**Conditional Use Permit —8001 S 120th Street —  
Nebraska Multi-Sport Complex**

**CITY OF LA VISTA  
PLANNING DIVISION  
RECOMMENDATION REPORT**

CASE NUMBERS: PCUP21-0006;

FOR HEARING ON: APRIL 7, 2022  
REPORT PREPARED ON: MARCH 30, 2022

Figure 4. Existing Intersection Capacity Analysis

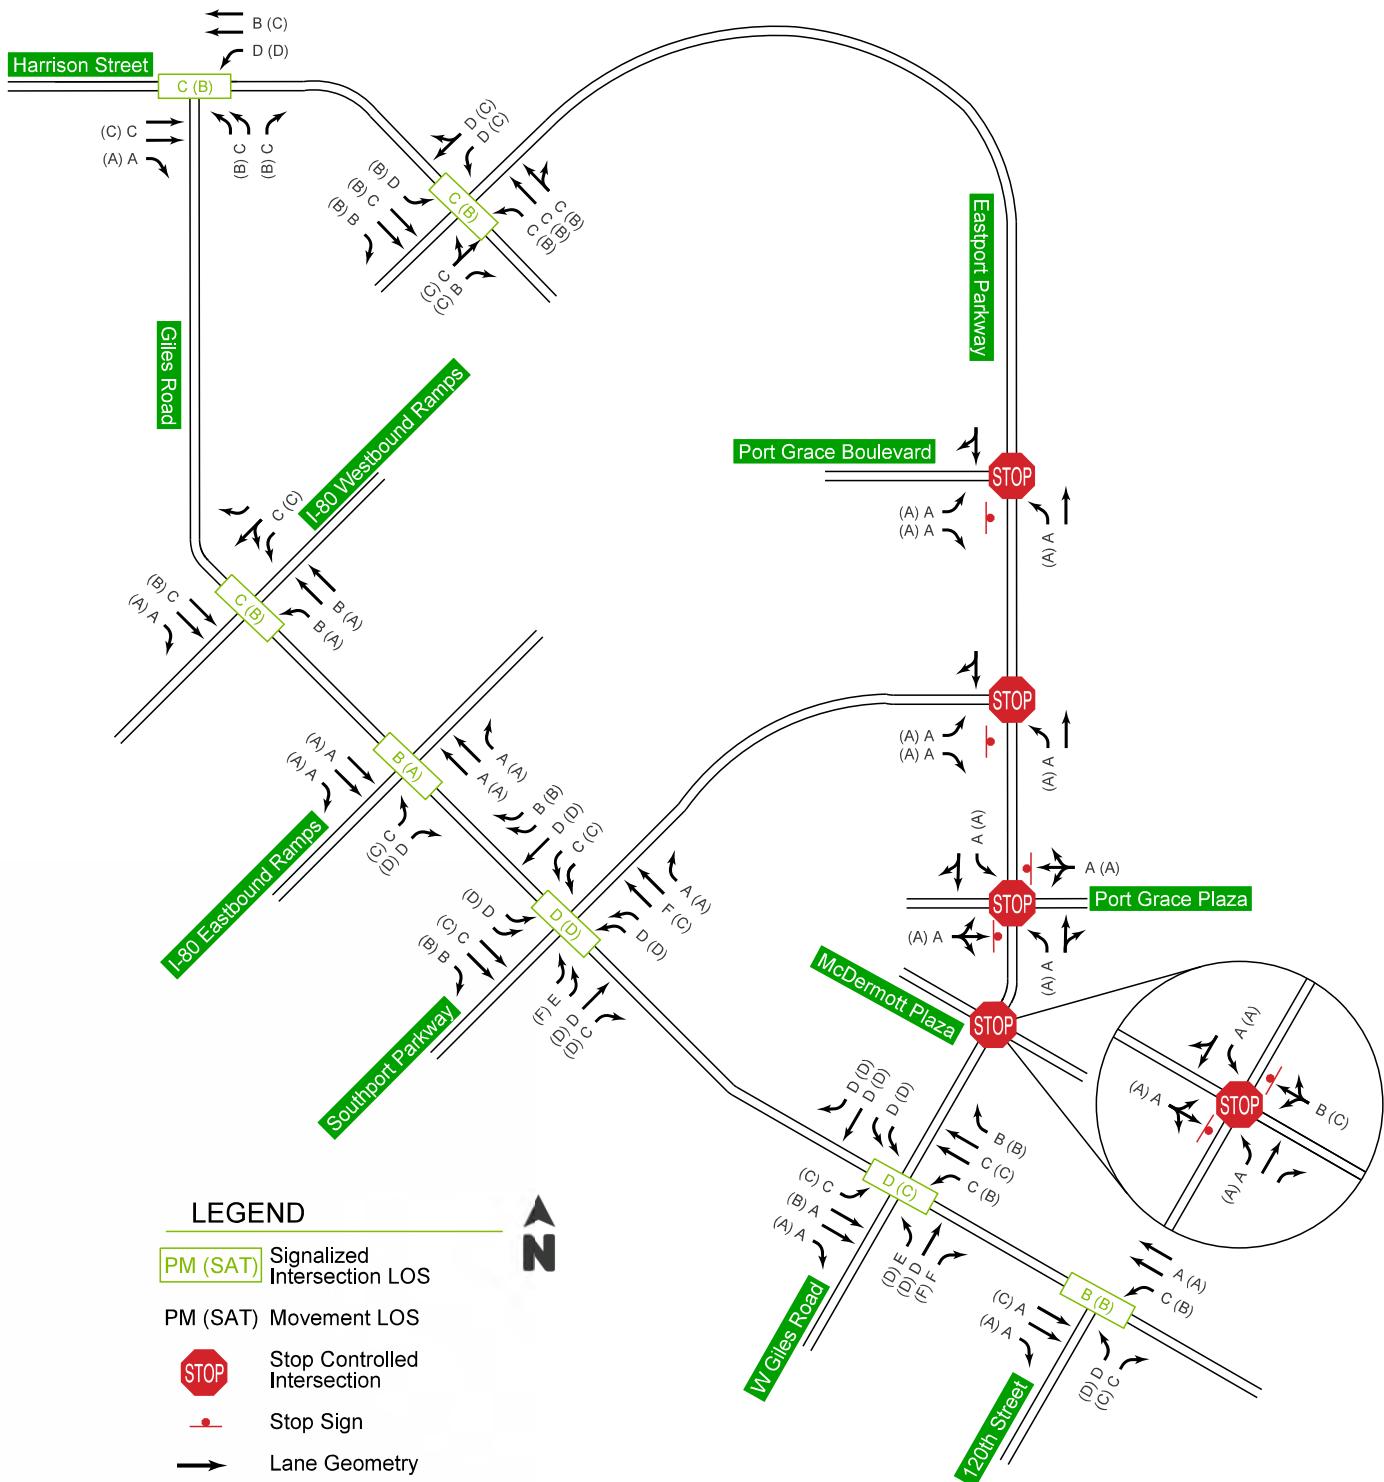
3. Page 6, 7 & 8 / Table 3 & Figure 4: LOS and movements do not match between text, table, and figure. Examples include the text states the “intersection of Giles Road and West Giles Road /Eastport Parkway which operates at LOS F in the PM peak hour” when Figure 4 show is at LOS D. Figure 4 shows E (D) for the eastbound left-turn at Giles and Southport, but text and table show E (F). The westbound through movement of Giles at Southport is also LOS F in the PM peak.  
*Please have the applicant update the text, table, or figure with the correct LOS.*

Figure 7. 2025 Background Intersection Capacity Analysis

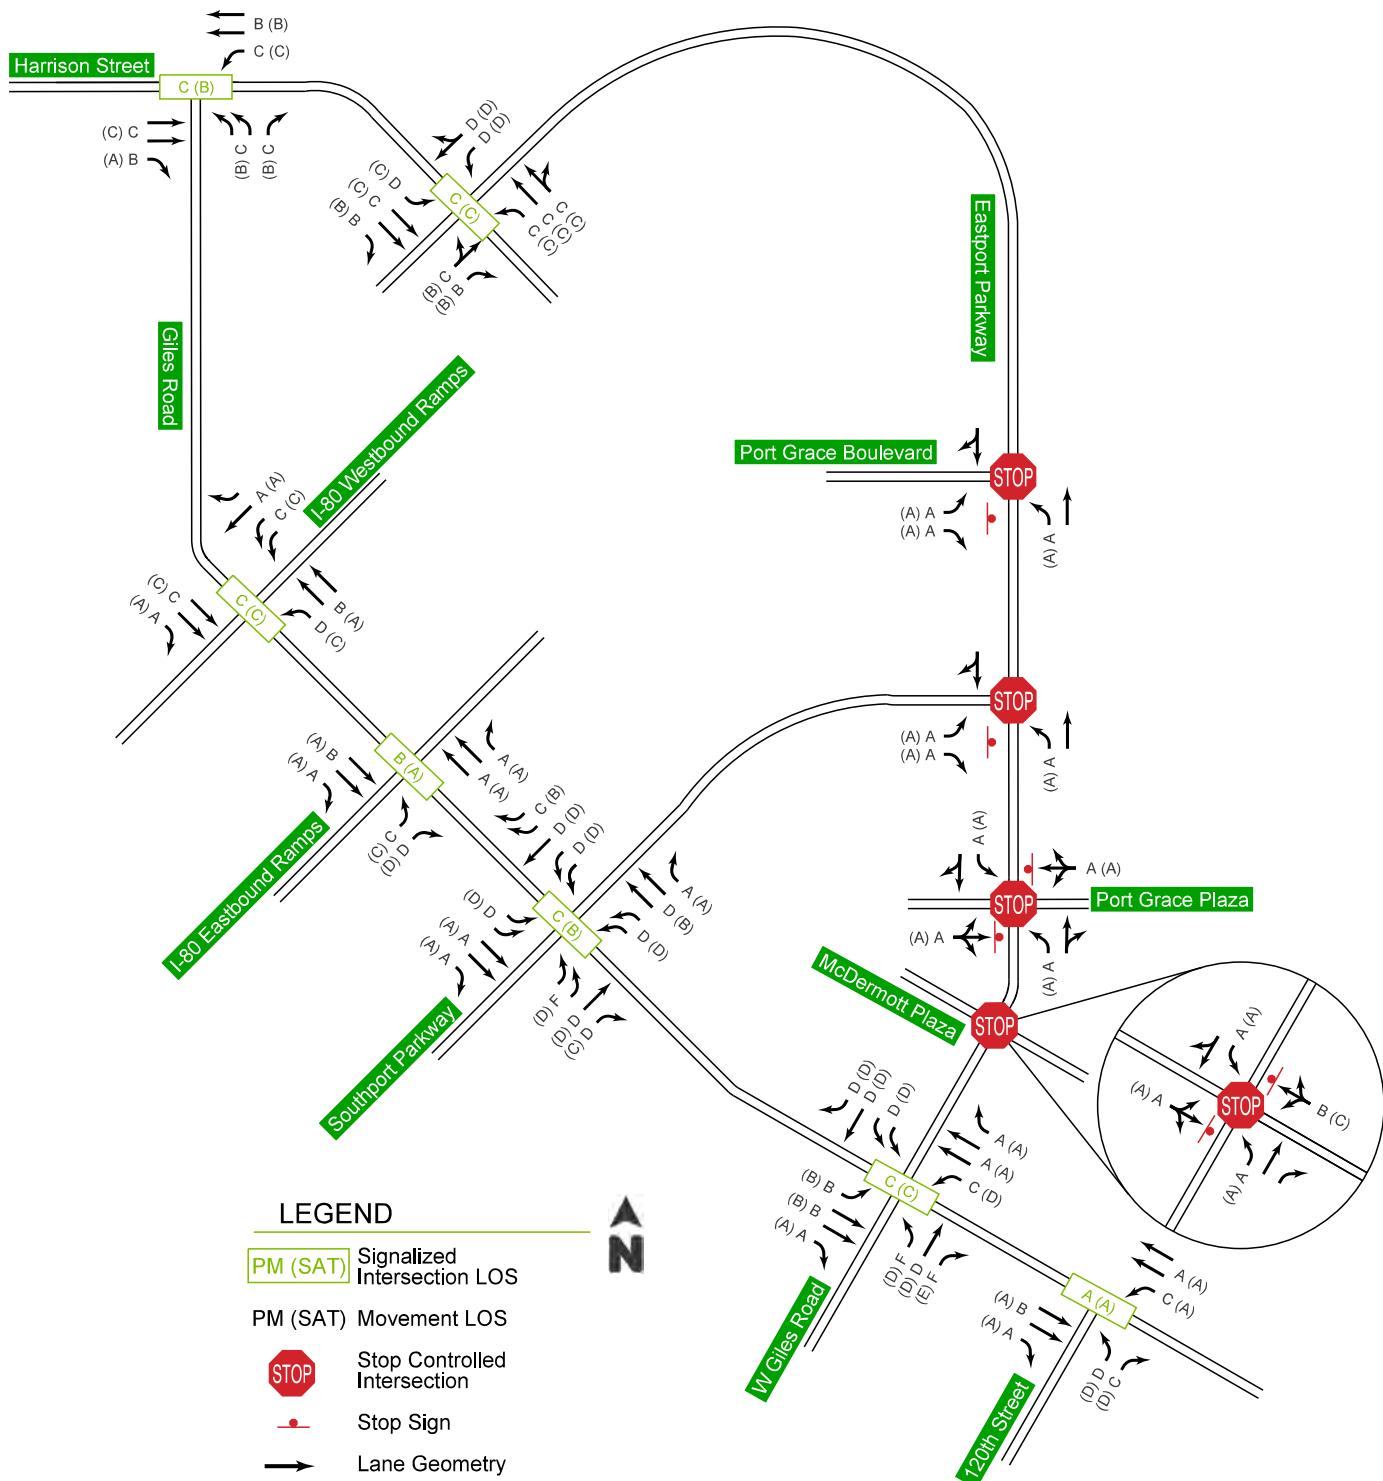
4. Page 8 & 14 / Figure 4 & Figure 7: Overall intersection LOS and individual movement LOS at the intersection of Giles Road with Southport Parkway improve from Existing [D (D)] to 2025 Background [C (B)].  
*Please have the applicant verify the LOS for 2025 Background with the modified phase splits.*

Figure 8. 2050 Background Intersection Capacity Analysis.

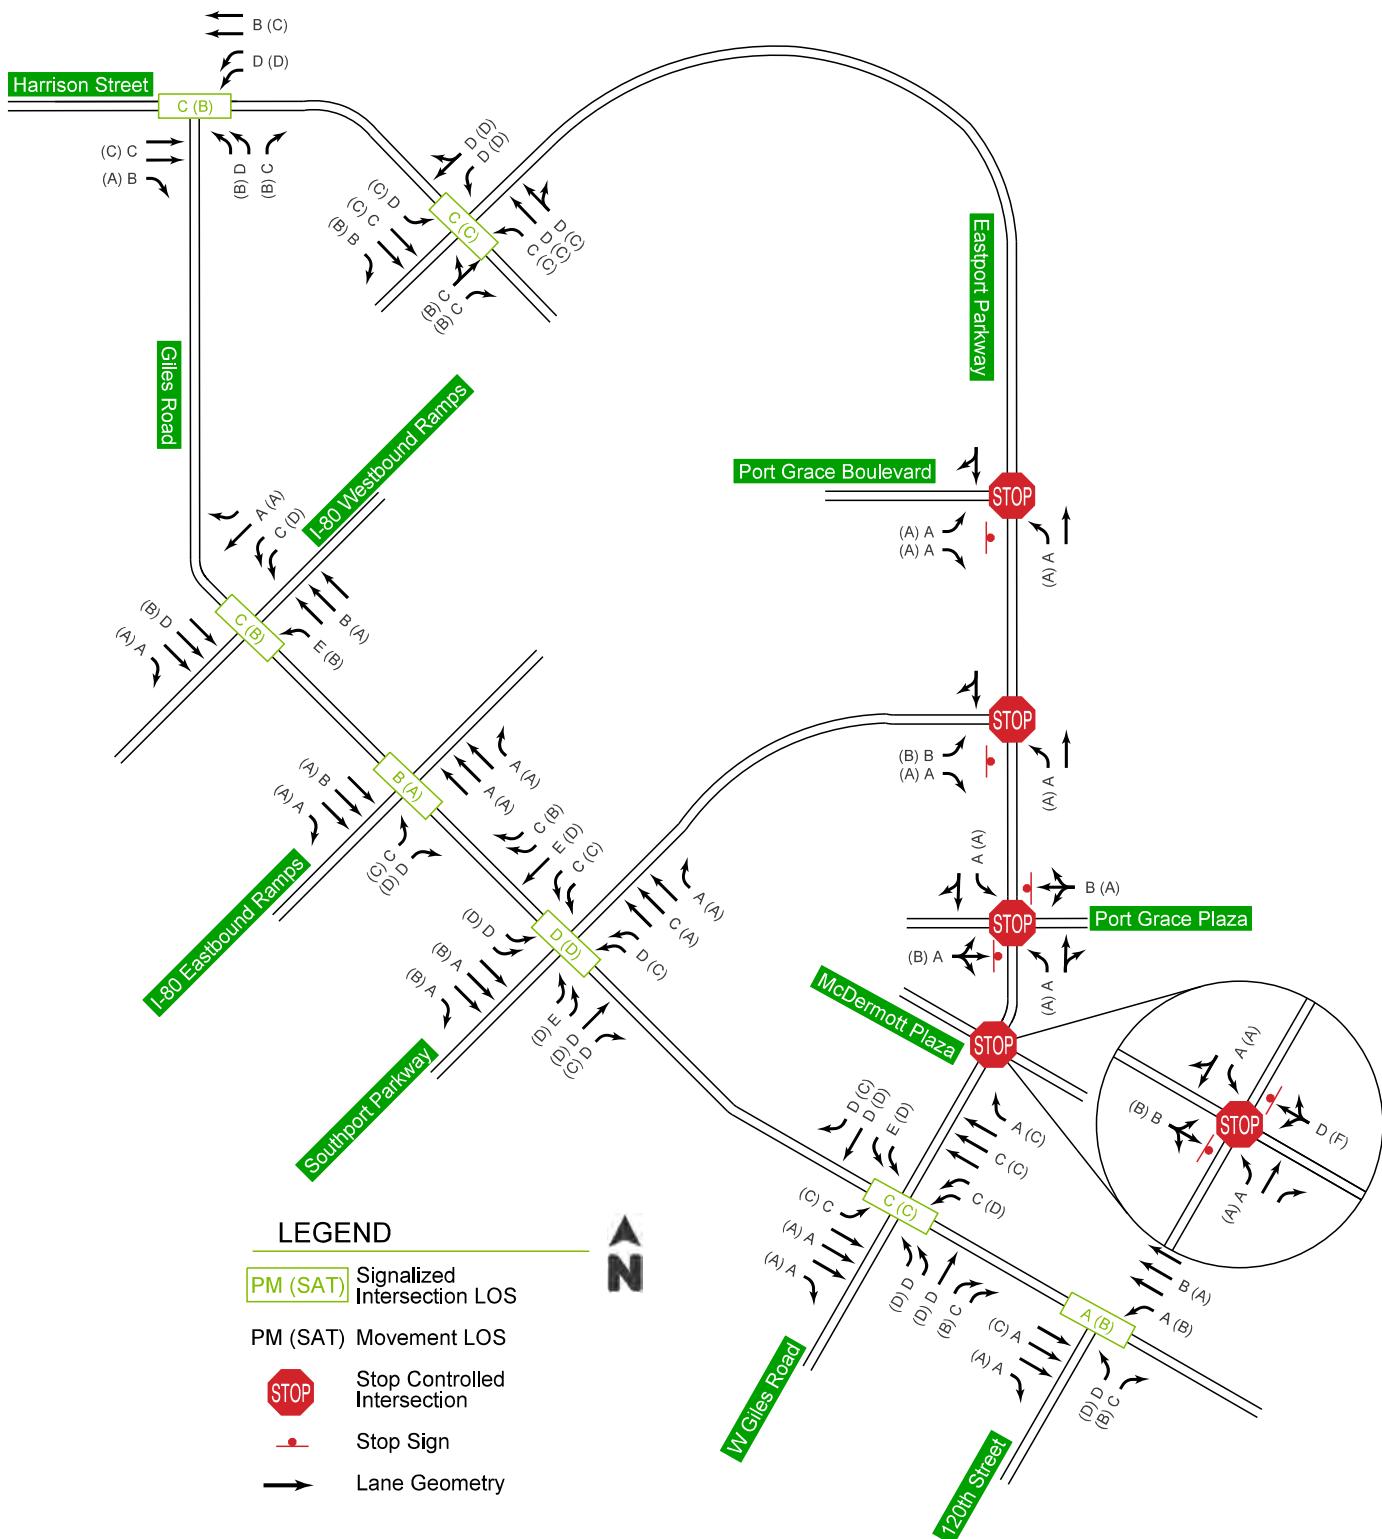
6. Page 15 & 17 / Figure 8: Dual westbound left-turn lanes are assumed to be included as part of the 2050 Background improvements. Figure 8 shows a single westbound left-turn lane on Harrison Street.  
*Please have the applicant show the correct lane arrangements and update the operational analysis at the intersection of Giles Road with Harrison Street for 2050 Background.*

7. Page 16 & 17 / Table 5 & Figure 8: Figure 8 shows the northbound left-turn movement on Giles Road at the I-80 Westbound Ramps as LOS E in the PM peak hour.  
*Please have the applicant add this movement, queues, delay, and V/C ratio to Table 5.*

Figure 9. Site plan

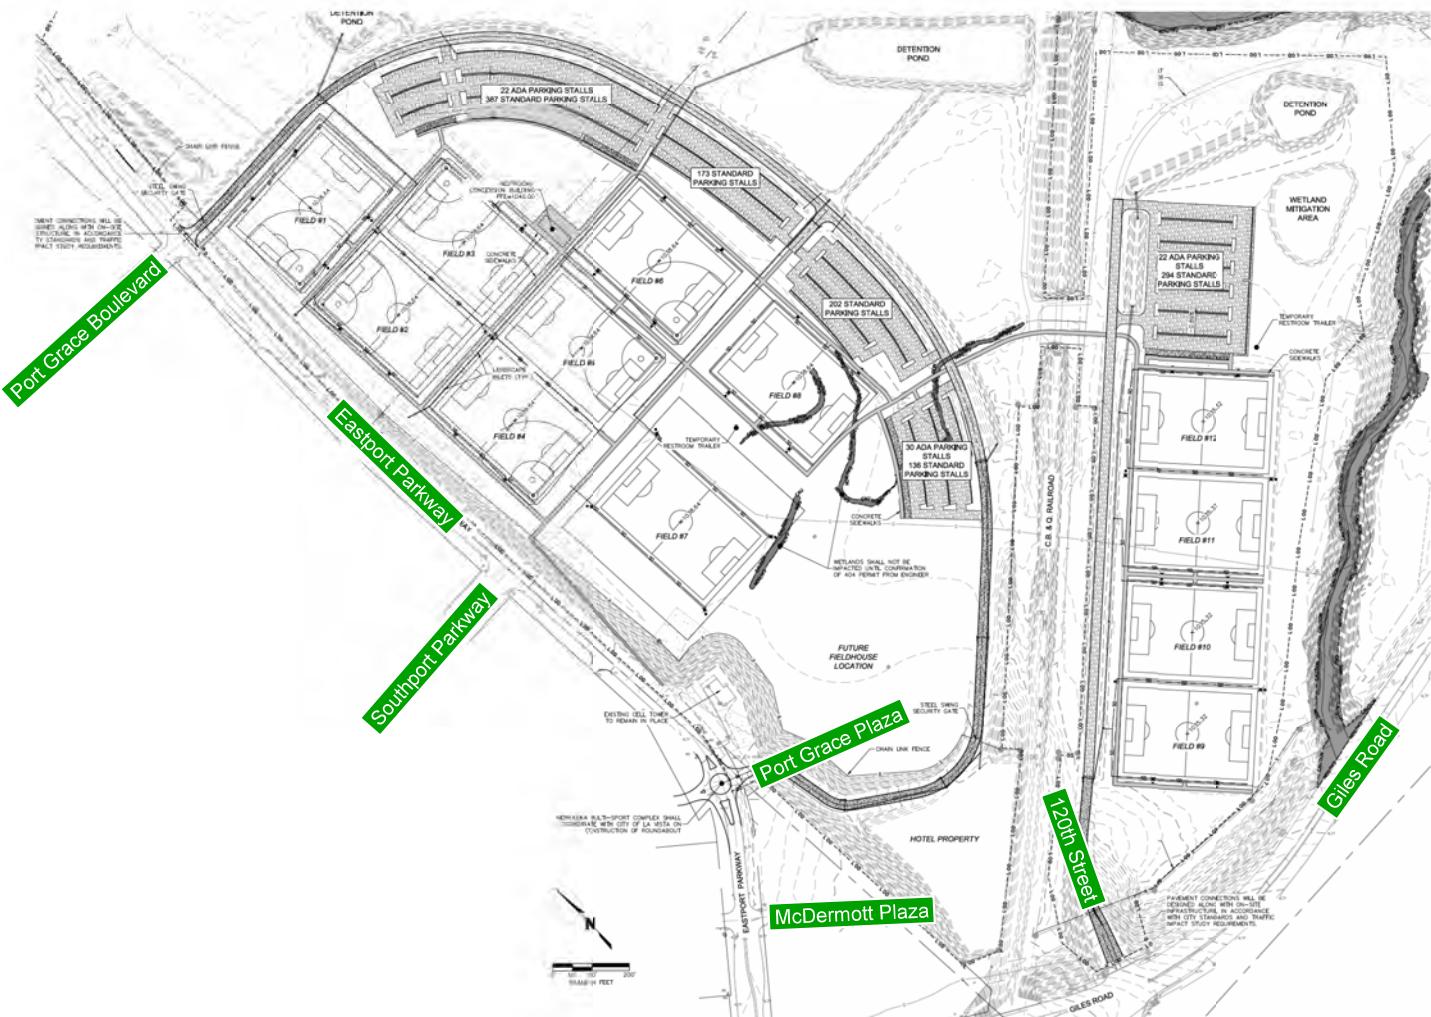
5. Page 19 / Figure 9: The site plan does not show parking lot locations, the grade-separated pedestrian bridge, the stadium field, or the standalone fieldhouse.  
*Please have the applicant include a revised site plan showing the locations of these facilities.*
